- RECORD PLANS -

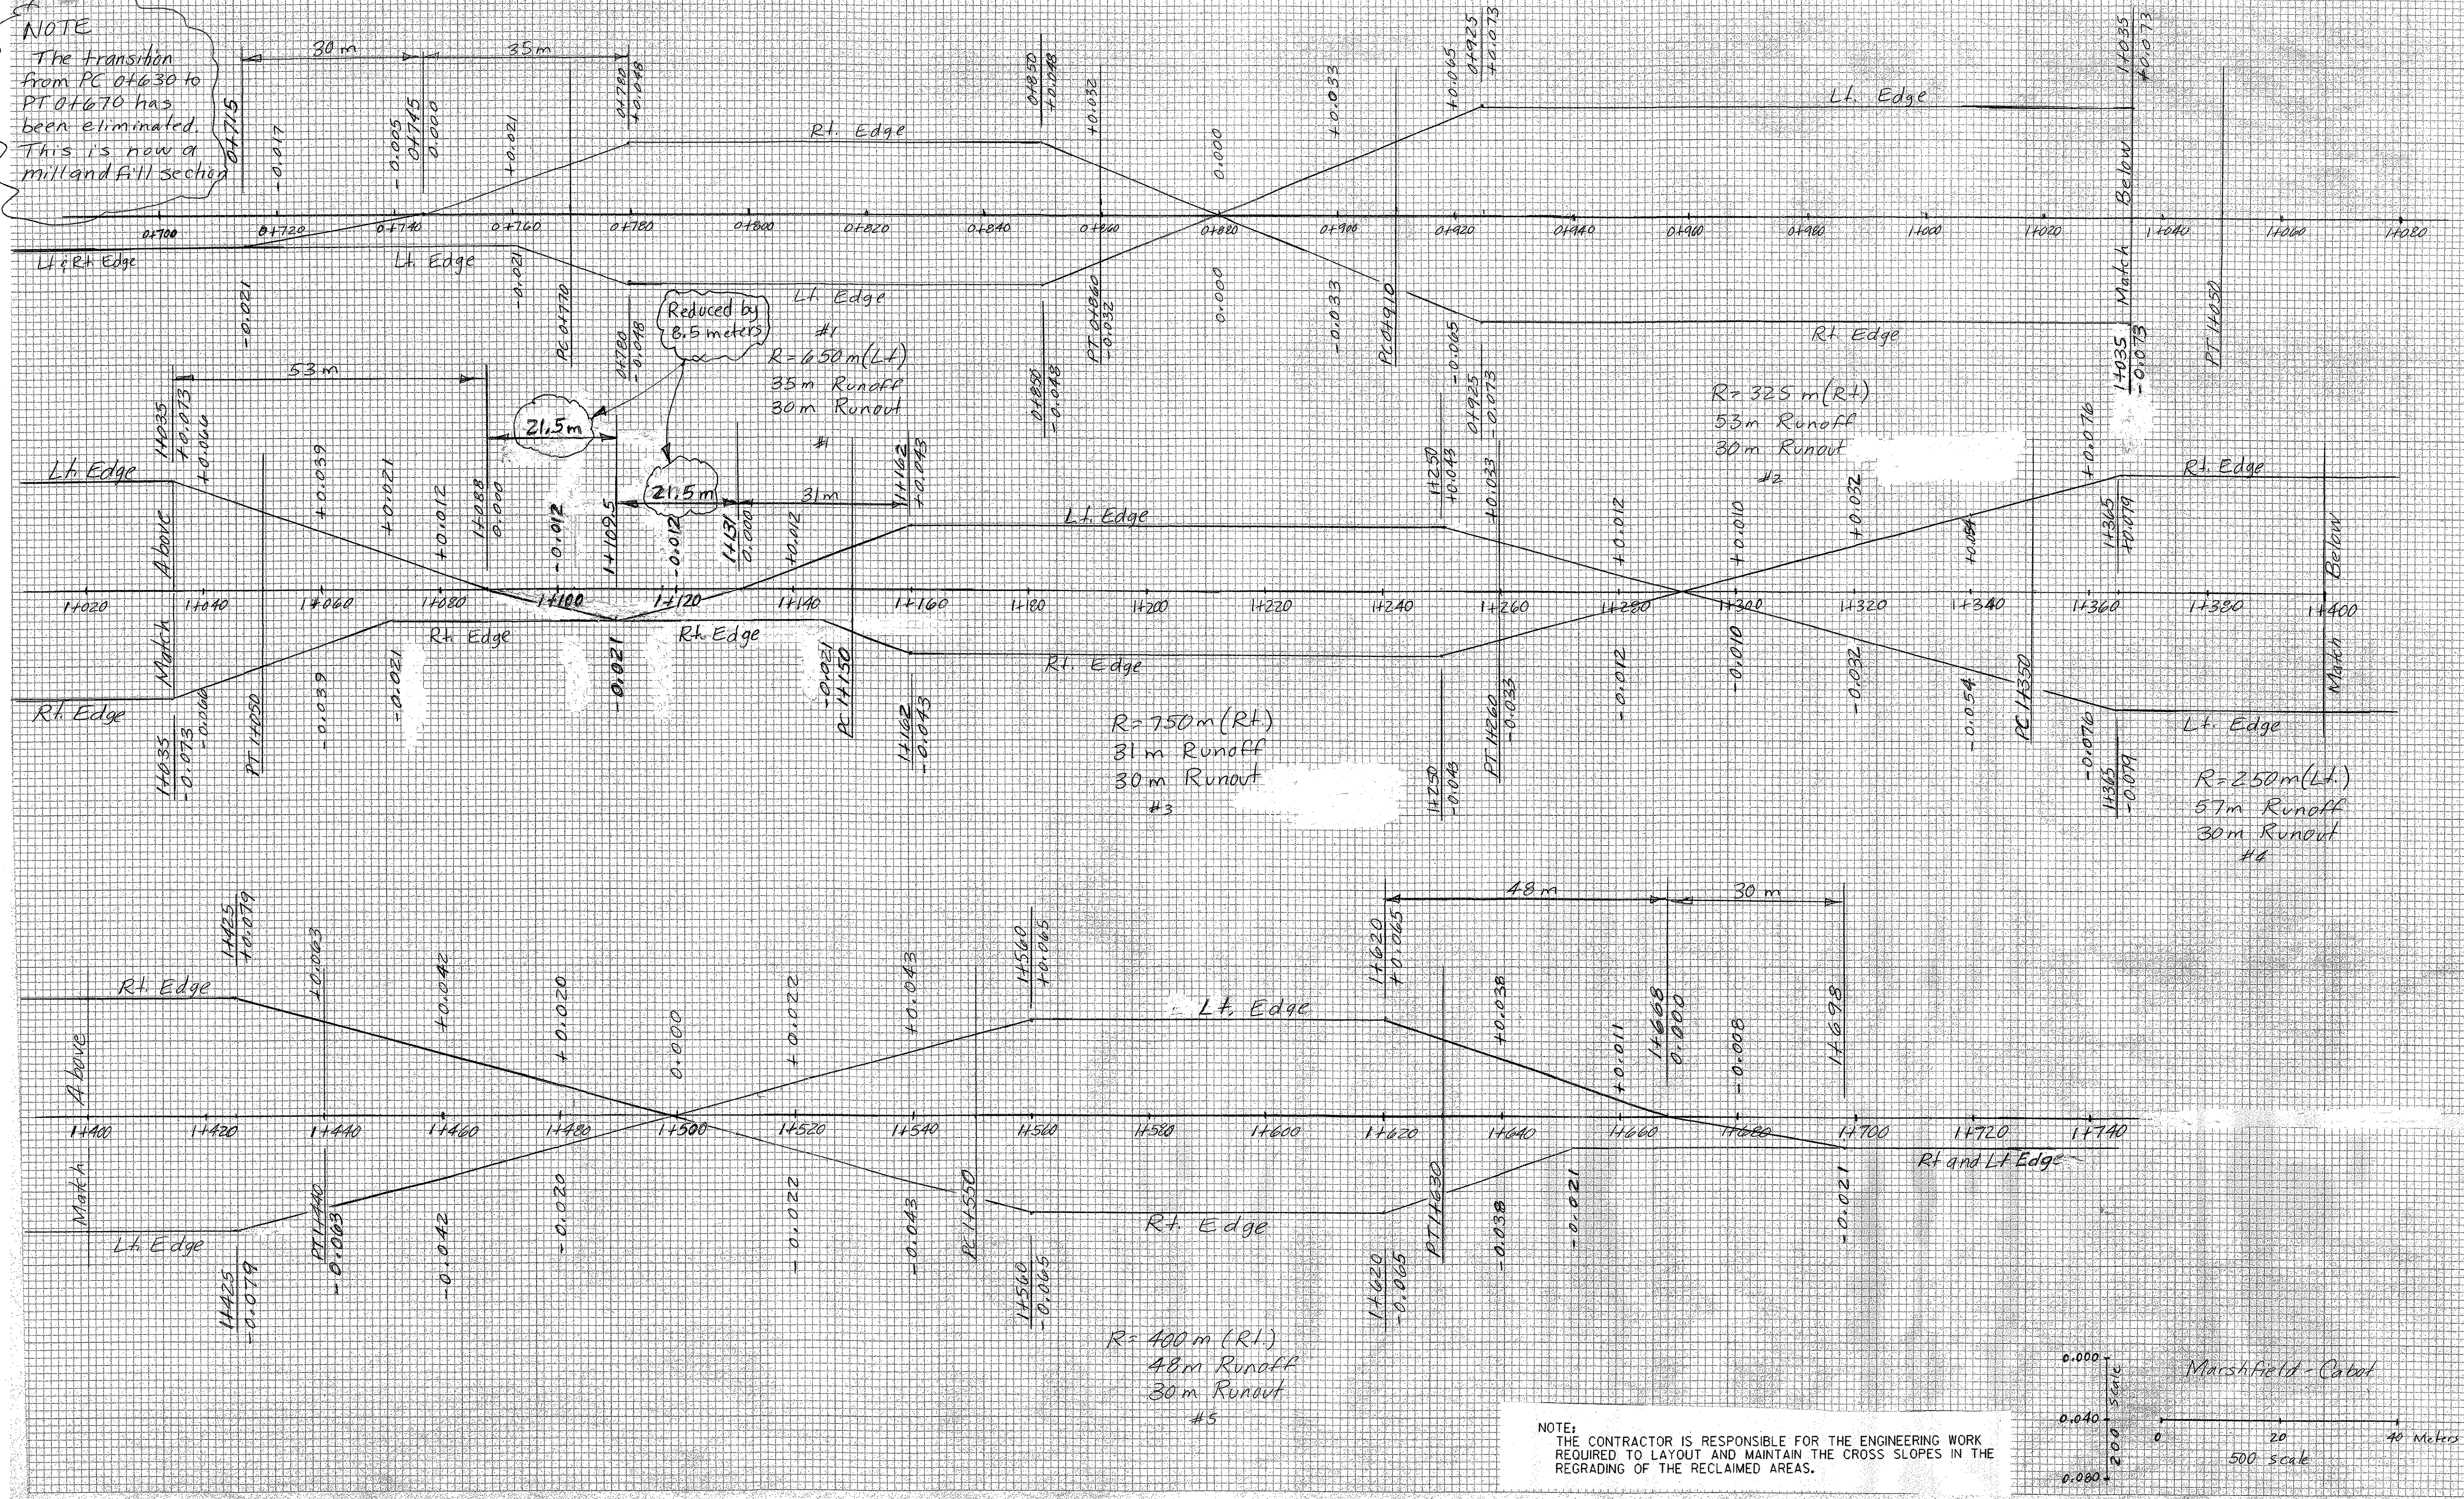
NOTE
The transition from PC 01630 to PT 01670 has been eliminated. This is now a mill and fill section.
